APPLICATION NO.	FILING DATE	FIRST NAMED INVENTOR	ATTORNEY DOCKET NO.	CONFIRMATION NO.
10/024,507	12/21/2001	Donald E. Bobbitt	42072	2198

# Office Action Summary

***Part II DETAILED ACTION***

(EXHIBIT A)

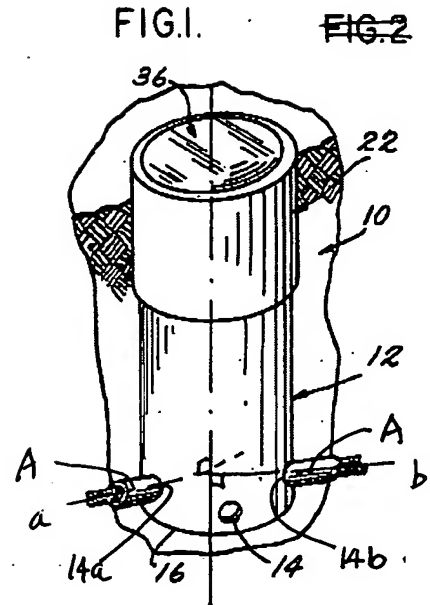
3. Claims 1, 3-7, 10-11, 13-14 stand rejected under 35 U.S.C. 102(b) as being anticipated by White (US Patent No. 5,156,454).

White shows and discloses a light fixture foundation comprising: a hollow shaft (12) having a tubular wall extending inherently along a central longitudinal axis, a plurality of cableway openings (14) extending through the tubular wall along axes substantially perpendicular to the central longitudinal axis, wherein the cableway openings (14) being located substantially in a same lever but laterally spaced from each other, at least two cableway openings (14a , 14b) extending through the tubular wall along a first axis (a-a) and a second axis (b-b) which are considered to disposed on diametrically opposing sides of the hollow shaft and are substantial parallel to each other which are non-coaxial as claimed (see Fig. 1 shown bellow), at least two cableways (A) supporting electrical wiring (18, 40) and being received in the respective cableway openings, said cableways being substantially at a same vertical lever such that the cableways are positioned co-planar with respect to each other (see Fig. 2), and a support member (22) for supporting a lighting assembly (30) coupled to the shaft, said support member having a passageway (26) in communication with the hollow shaft to receive the cableways such that the cableways can be extended through the passageway without interfering each another. Notice, the cableways are inherently “rigid” than the wires (18) for guiding the wires (18) thought the opens

In response to applicant's argument that White does not anticipate the claimed invention because White does not disclose "rigid cableways" having centerlines disposed along the substantially parallel and non-coaxial axes as recited in both independent claims 1, 10, 16, and 19. Applicant's arguments have been fully considered but they are not deemed persuasive.

is not treated on merits. In fact, the cableways (A) of Whrite's device are considered to be substantially "rigid" than the wires (18) for guiding the wires through the wall and the passageway. Second, as mentioned by applicant, White shows the light fixture foundation having holes (14) disposed around the hollow shaft (12) at different positions aground the surface of the hollow shaft. Due to the diametrical shape, the adjacent holes (14) of White are considered disposed on diametrically opposing sides and laterally spaced from one another since the hollow shaft is circular in shape, and the adjacent holes (14) which is disposed at 0° and 90°, or 90° and 180° are considered to have axes being non-coaxial (see EXHIBIT A shown above) but disposed co-planar (the axes are perpendicular to each other in same level. See Figs. 1 and 4) as claimed. In addition, applicant only recites "the cableway opening extending through the tubular wall along a first/second axis", technically, an opening is not necessary to be a "circular" but would any other shapes, so the axis would be located anywhere within the opening, and directs to any directions (See illustration show in EXHIBIT A). Since applicant does not specifically define where are the first and second axes located along the cableway openings and how the axes disposes as relative to the openings, the opposing openings (14a, 14b) of White's device are considered to have first and second axes (a, b) through the wall and parallel and non-coaxial to each other as broadly read on the claims. And, the cableway (A) inherently has a centerlines disposed along the axes as claimed. Further, White teaches the openings being used for separately positioning the cableways in different positions which solves the same problem of preventing the cableway interfering each other as claimed invention. So White's device is considered to broadly read on the claimed invention.

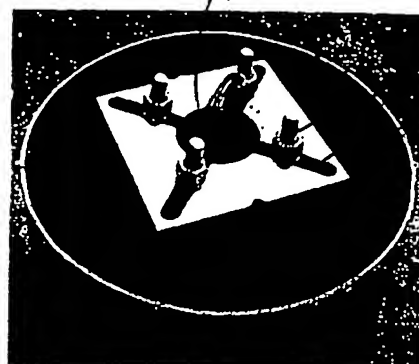
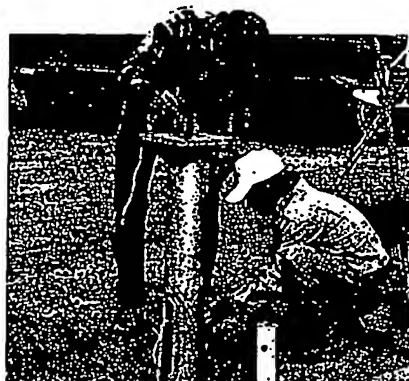
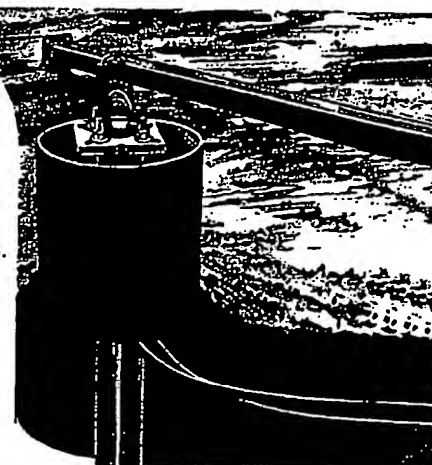
4. Claims 1, 3-20 are rejected under 35 U.S.C. 103(a) as being unpatentable over Hubbell Power system, Inc. (see Lighting Foundations, CHANCE, Bulletin 2-9705) in view of Gagliano (US Patent No. 5,039,256).

Hubbell Power Systems, Inc. (see attachment) teaches installing on site a lighting fixture foundation comprising a method of excavating a trench (a) having a depth and a width sufficiently receiving the lighting fixture foundation, the lighting fixture foundation comprising an elongated hollow shaft (b) having cableway openings (c) being precut to extend through diametrically opposite surfaces of the tubular wall of the shaft (see the previous page of the attachment), wherein the cableway openings are aligned in a same lever, an anchor (d) at the lower end of the hollow shaft for driving and supporting the hollow shaft through the bottom the trench into the ground, a support member being a base plate (e) fixed to an axial upper end of

the shaft, the base plate having notches (f) to receive bolts (g) for releasably supporting a lighting assembly thereon, the support member having a passageway (h) in communication with the hollow shaft such that cableways (i) are extended through the cableway openings (c) in opposite directions and through the passageway of the support member to the lighting assembly.

Wherein, Hubbell Power System teaches the lighting fixture foundation being installed by obvious alternative steps of excavating a trench in suitable depth and width, anchoring the hollow shaft in the trench by a hydraulic rotary equipment, placing cableways supporting electrical wiring in the trench on opposite sides of the shaft, inserting the cableways into the cableway openings and extending upward through the passageway of the support member, mounting a lighting assembly being coupled to the support member, and connecting the electrical wiring of the cableways with the lighting unit supported by the light support. Hubbell Power System does not specifically define the hollow shaft having the cableway openings formed on the diametrically opposite surfaces of the hollow shaft being not co-axial such that the cableways are laterally spaced from each other as claimed for receiving cables being substantially perpendicular to the longitudinal axis of the hollow shaft and extending spaced apart without interfering with one another. First, the foundation of Hubbell Power System teaches the hollow shaft having the cableway openings (c) formed on diametrically opening sides of the shaft, and the opposite sides cableway openings having axes would inherently located laterally spaced from each other. Second, Gagliano teaches a foundation to be anchoring in ground, comprising a hollow shaft having a tubular wall (1) extending along a central longitudinal axis, a plurality of openings (4 or 5) extending substantially perpendicular to the central axis of the hollow shaft, wherein the openings include a first opening and second opening
